COM CTLE MODEL UPDATE PROPOSAL

(in support of Comment #45)

IEEE 802.3bs 400 Gb/s Task Force
Whistler, Canada, May, 2016

CDAUI-8 COM CTLE

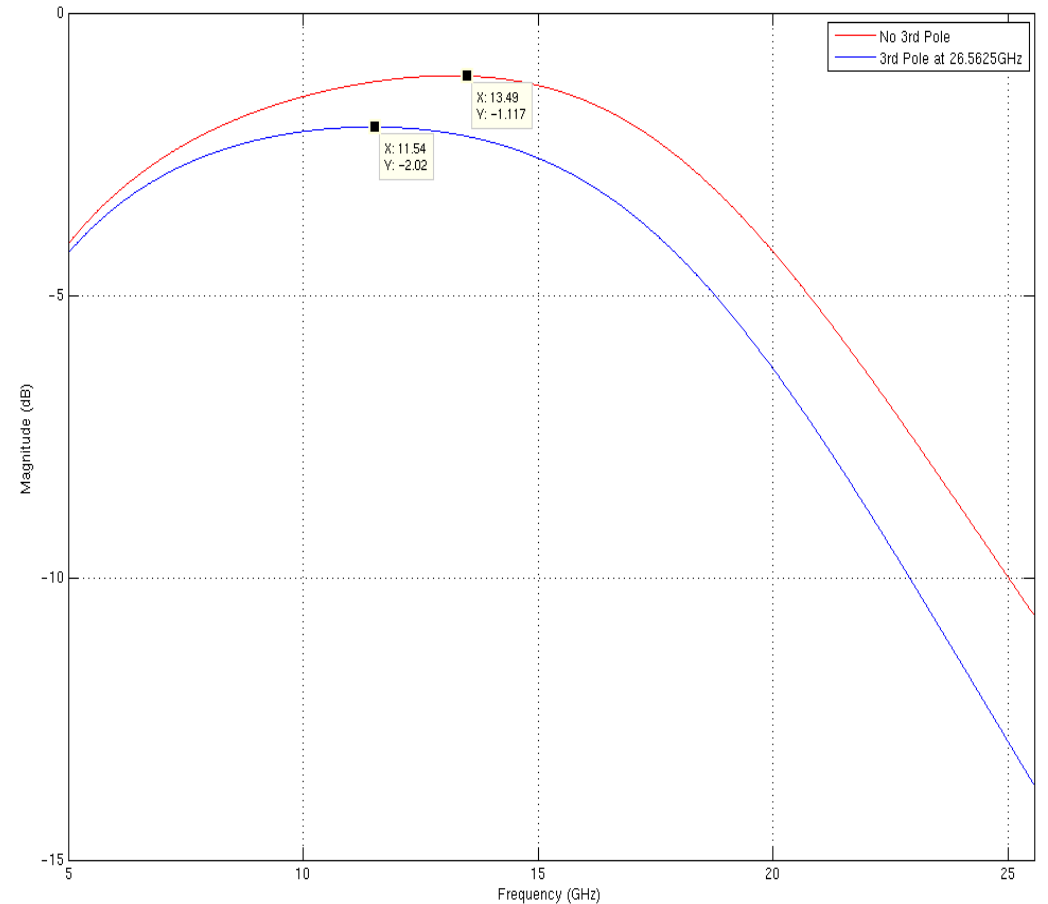
- Current draft version:

- $H_{ctf}(f) = \frac{(10^{g_{DC_LOW}/20} + jf/fz_{low})}{(1 + jf/f_{p_low})} \cdot \frac{(10^{g_{DC}/20} + jf/fz)}{(1 + \frac{jf}{f_p})}$
- No b/w pole in the main section of the CTLE.

- Comment #45: Re-introduce 2nd pole at f_b .
